68 Long Beach

Penn Reel Parts list for Model: 68 Longbeach

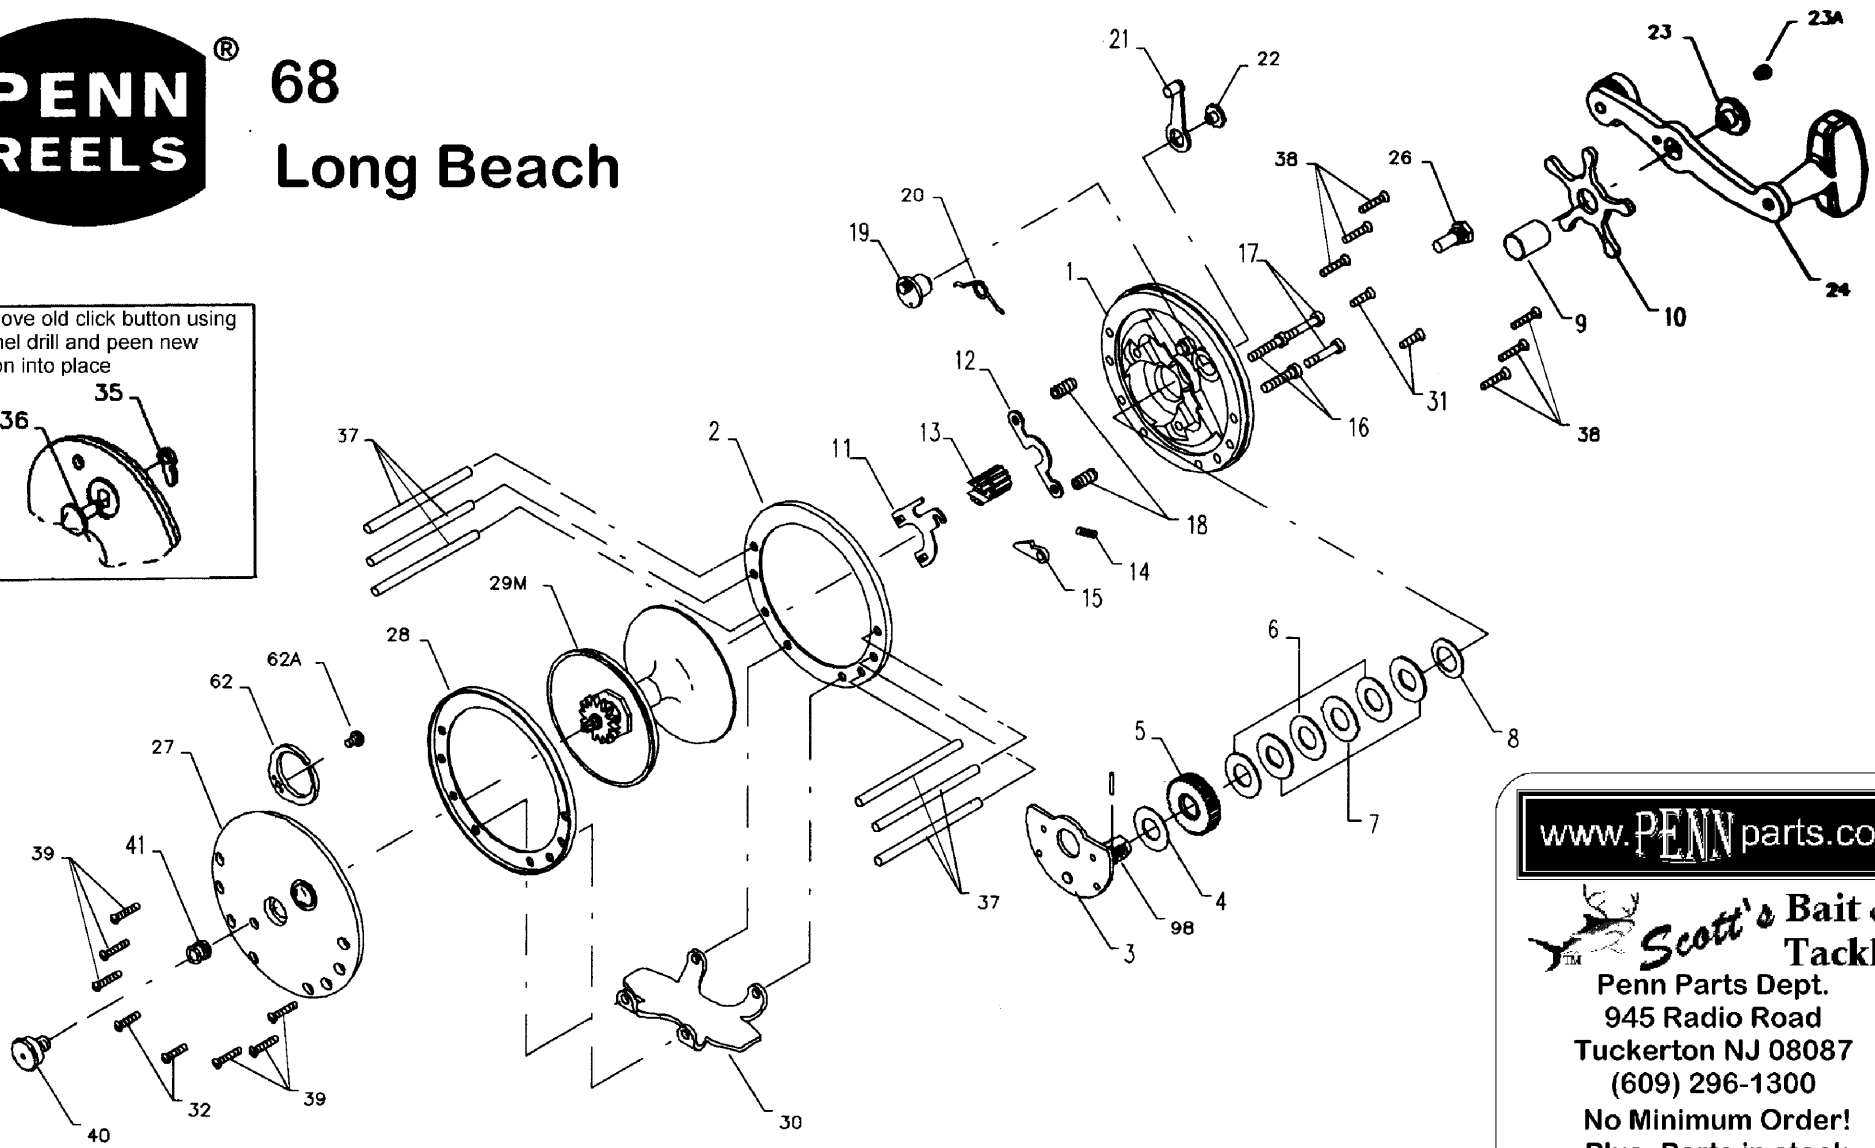
Change: Older reels prior to 1953 used the 14-60 bent copper dog spring.
After 1953, this changed to the current 14-99 coiled dog spring.

***** IMPORTANT DESIGN CHANGE NOTE (MEASURE!)

On older 66, 67 and 68 reels a 36-60CH may be required. It measures .248 (roughly 1/4 inch) from just under the cap to the edge of the dropdown.

The 36-209 measures .283 (roughly 1/16 inch longer) Penn may have changed the

27-66 plate (Used on 66, 67, and 68) at some point, although there are no notes to that effect.

Remove old click button using dremel drill and peen new button into place

To replace the click tongue on models where it is peened into place, use a dremel drill with a fine tip to remove the old click tongue and click button. Then peen the new 36-209 into place.

Any reel that uses the 36-209 button can use:

36N-209 button and a 69B-600 removable c clip

This newer style is held by the clip instead of being peened in place.
